FLORIDA POWER AND LIGHT COMPANY

TURKEY POINT NUCLEAR GENERATING UNIT NO. 3

AMENDMENT TO FACILITY OPERATING LICENSE

ATTACHMENT TO LICENSE AMENDMENT NOS. 34 AND 28
FACILITY OPERATING LICENSE NOS. DPR-31 AND DPR-41
DOCKET NOS. 50-250 AND 50-251

FIGURE 3.2-3a

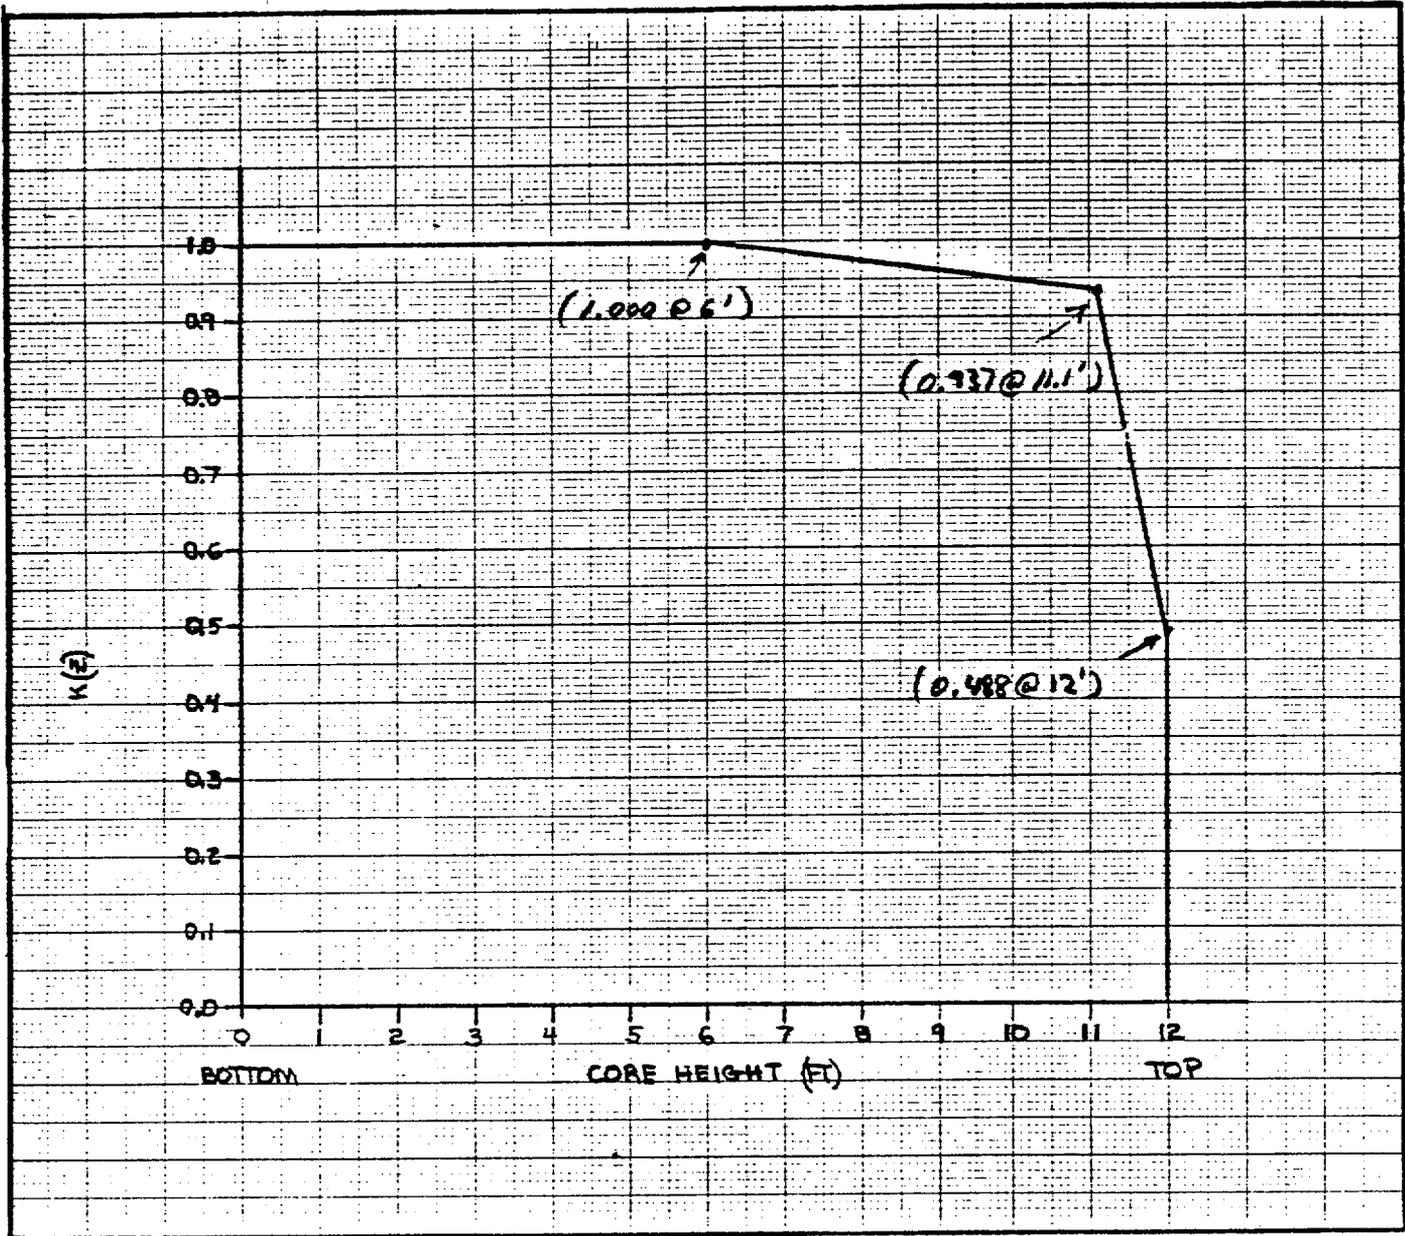
The amendments consist of changes in the Technical Specifications that add a new K(Z) curve (Figure 3.2-3a of the Technical Specifications).

Where P and Z are defined in 1. above and K(Z) is given in Figure 3.2-3a,

To insure that the above limits are met, the licensee has submitted a revised $K(Z)$ function for cycle 4 burnup greater than or equal to 5,000 MWD/MTU. We have examined the figure and find it to be acceptable for inclusion in the Technical Specifications for Turkey Point.

- 2. With steam generator tube plugging $>$ 15% and \leq 19%, the hot channel factors must meet the following limits at all times except during low power physics tests:

$$F_q(Z) \leq (2.05/P) \times K(Z), \text{ for } P > .5$$

$$F_q(Z) \leq (4.10) \times K(Z), \text{ for } P \leq .5$$

If predicted F_q exceeds 2.05 with tube plugging $>$ 15% and \leq 19%, then power will be limited to the rated power multiplied by the ratio of 2.05 divided by the predicted F_q , or augmented surveillance of hot channel factors shall be implemented.
